## Planning Commission Staff Report

**SUBJECT:** Planning Application (PA23-06) for Design Review (DR23-02), Conditional Use Permit (UP23-02), and Modification (MOD25-0195) for construction of a new 7,025 sq. ft. showroom building for sales of food service trailers and concession carts on a 0.77-acre vacant lot at North Lincoln St and West Vaughn Rd.

# ELEVATION VIEWS OF THE PROPOSED BUILDING

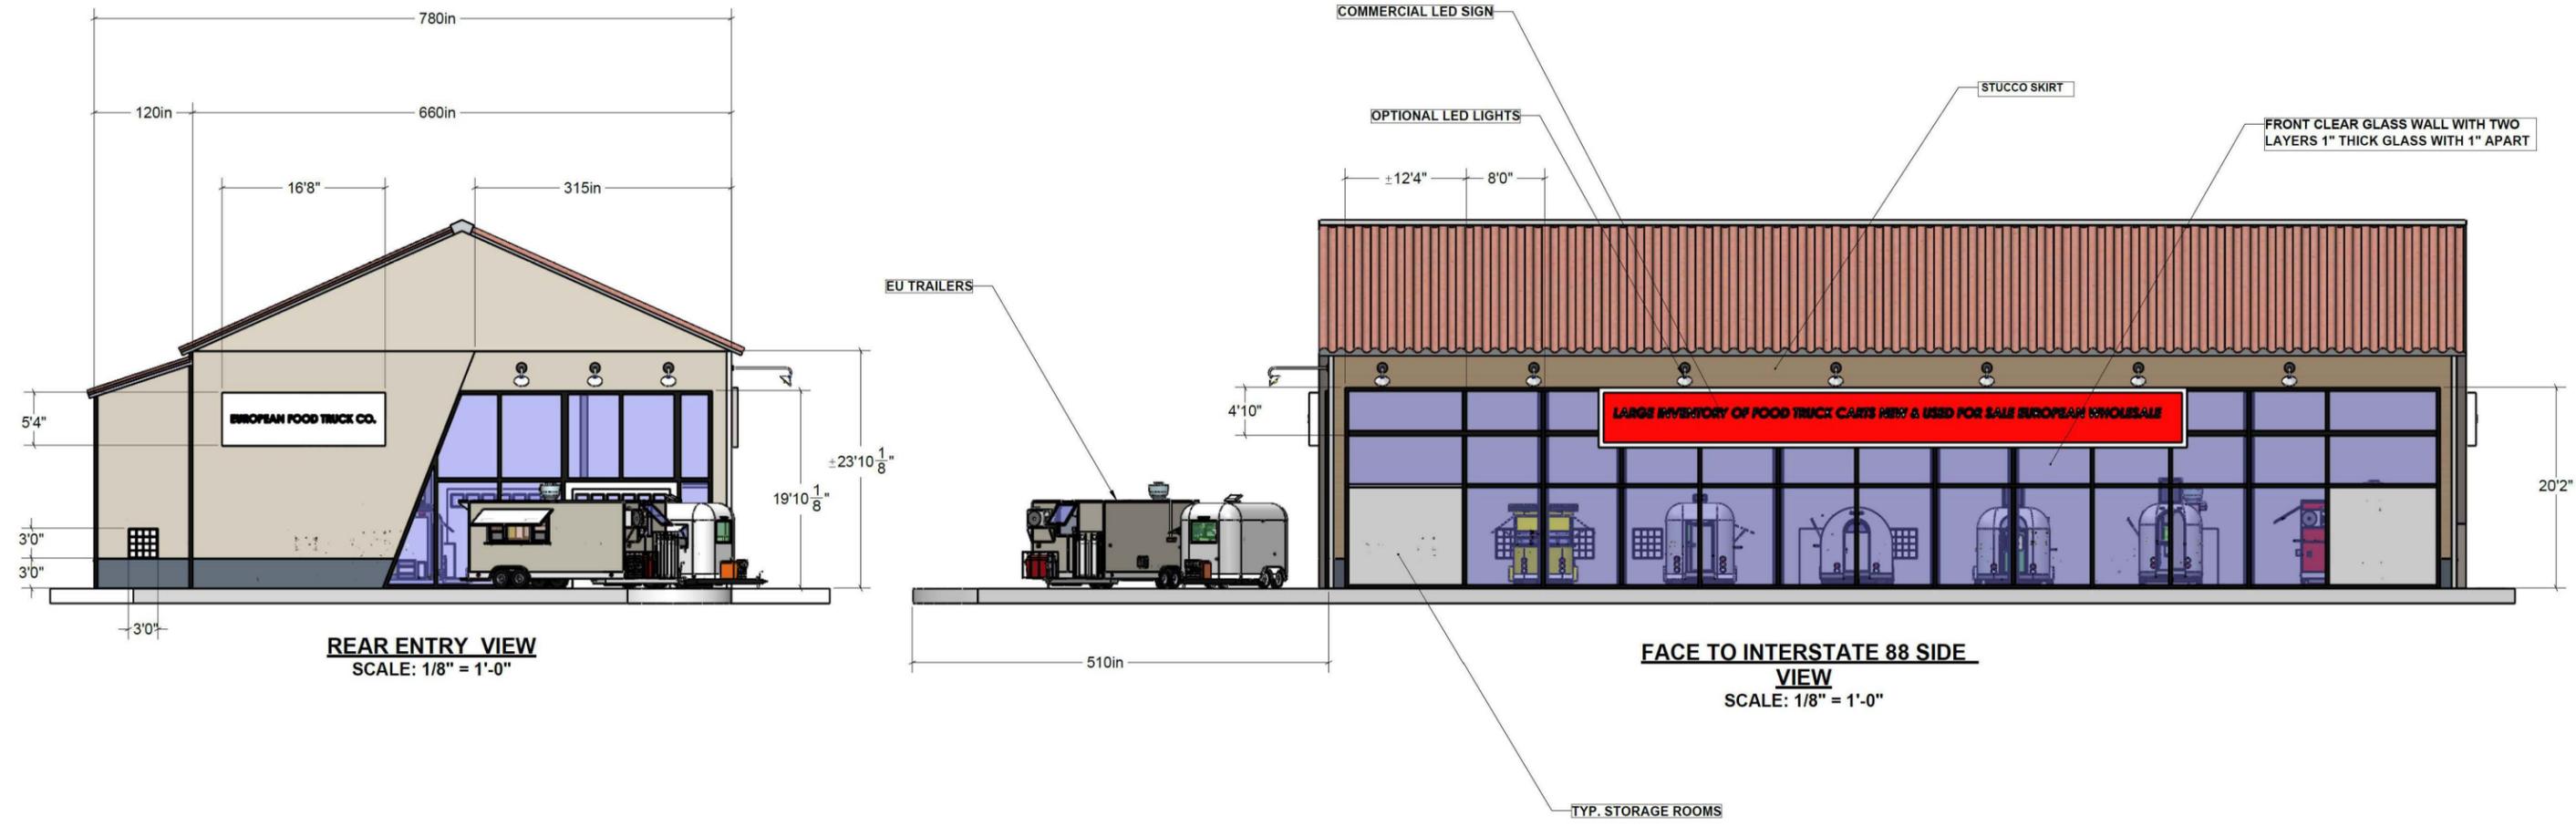
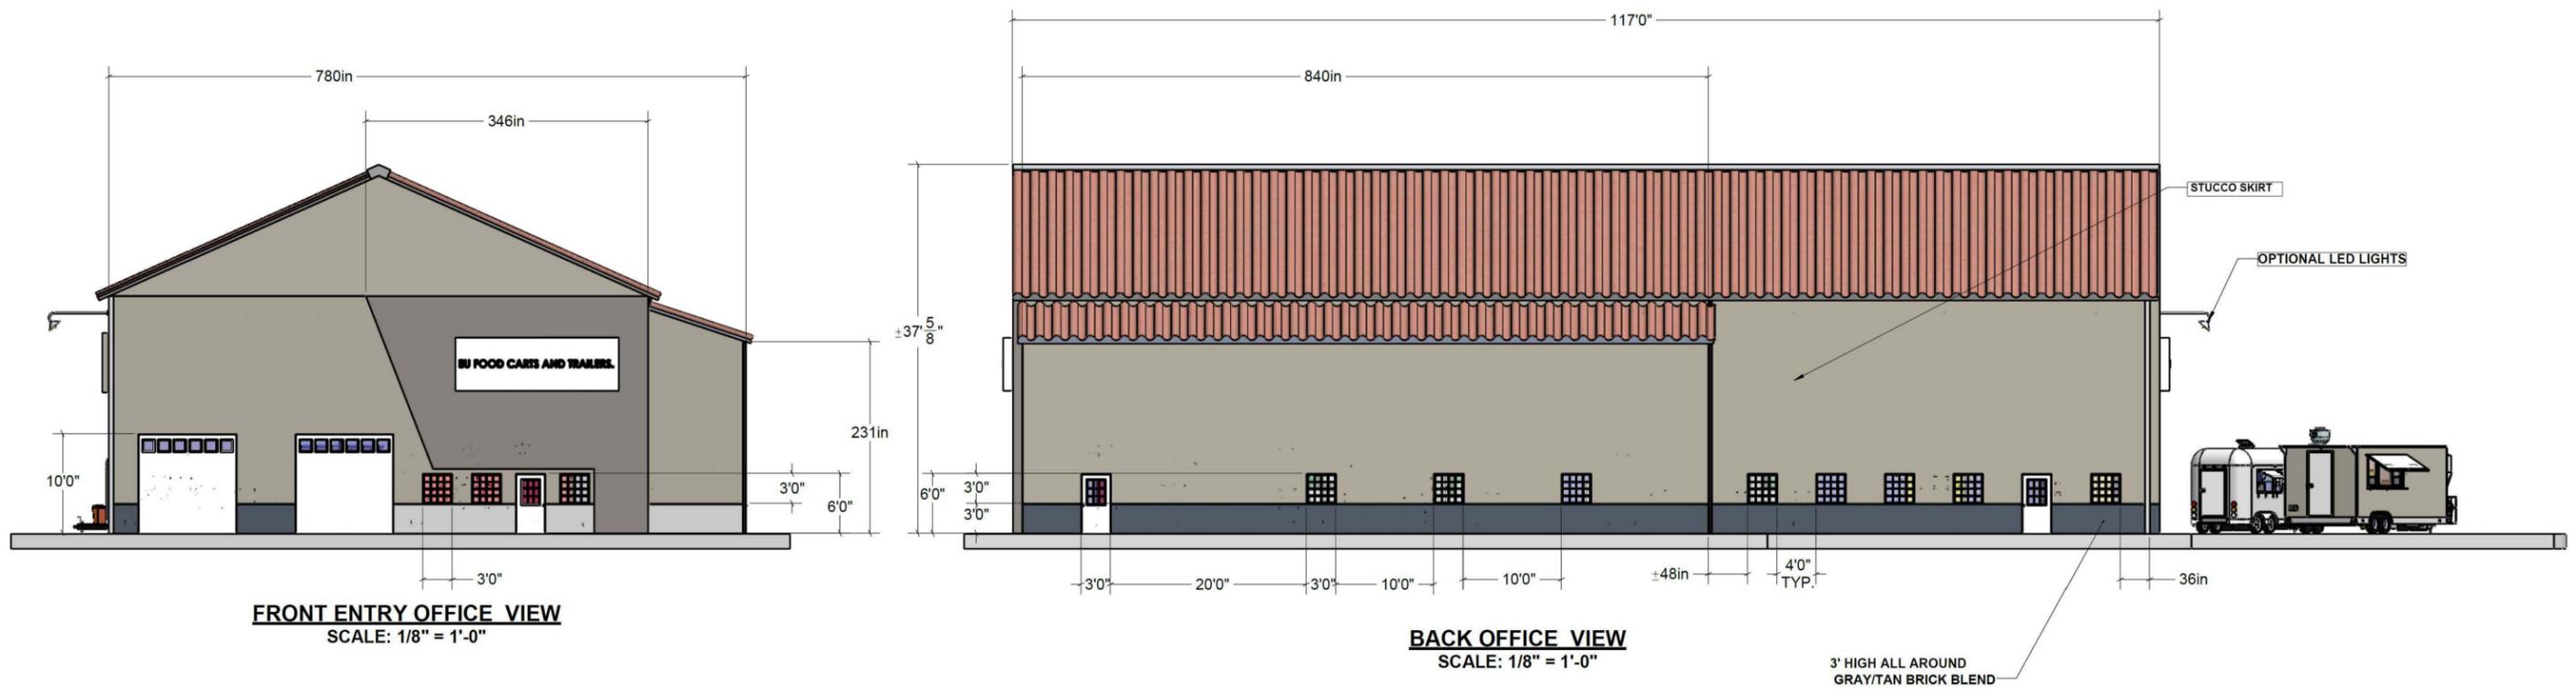
A condition of approval has been added that requires the applicant to either wrap the windows and entryway features found facing I-80 to the portions facing West Vaughn and North Lincoln St or another alternative building articulation or architectural elements that are found acceptable by staff. Doing this, along with the neutral color palette and the extensive use of stone veneer establish an attractive appearance that will stand the test of time (DGP, Land Use and Community Character Element, Policy LCC-5.8, pg. 3-28). The building is also set an appropriate distance back from the street and freeway.

- The applicant shall wrap the side and rear windows around to the front of the business along West Vaughn Road and North Lincoln Streets. The design shall be subject to Planning review and approval prior to issuance of a building permit;

Finding: As previously noted, the project will need to be modified to enhance the true front of the proposed building, by carrying over the windows and stone in the back of the building to the front. As modified, the building, along with the proposed landscaping and signage will have an attractive, visually consistent and modern appearance that will fit well within the neighborhood.

Finding: As modified by the conditions of approval, the design at building permit issuance will be acceptable. Presently, the applicant is proposing to have an unenhanced design facing the street, while the back is enhanced to those driving along I-80. The project has been conditioned to extend the glass and stone found along the side facing I-80 to the front of the building. This will create an attractive overall design.

- a. The applicant shall wrap the side and rear windows around to the front of the business along West Vaughn Road and North Lincoln Streets. The design shall be subject to Planning review and approval prior to issuance of a building permit;
